Keystone RV Company

SAFETY ADVISORY # 20-381

Carbon, Cougar, Fuzion, Impact, and Raptor Fifth Wheel TV Antenna

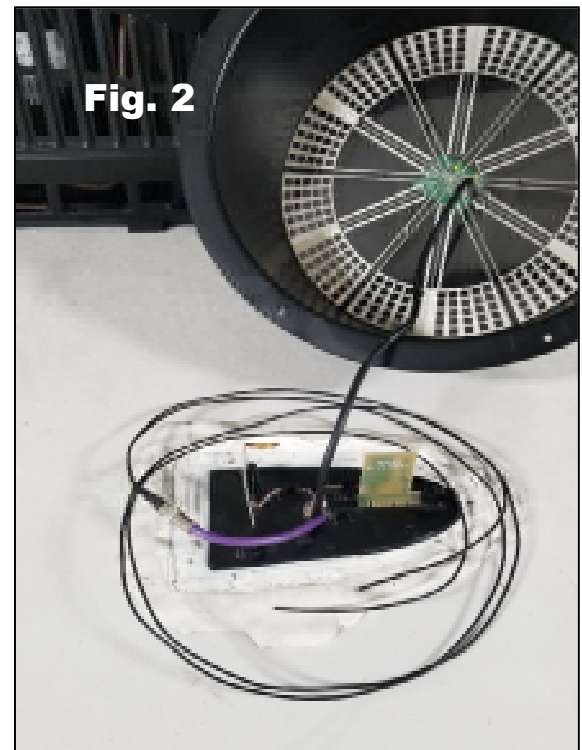
Locate the mounting base for the Furrion antenna and remove the exterior 7 screws to detach it from the roof. Remove the 4 screws out of the bottom of the base and pull the mount for the 4G antennas out of the base, Figures 1 and 1a. Discard the unused portion of the mounting base.
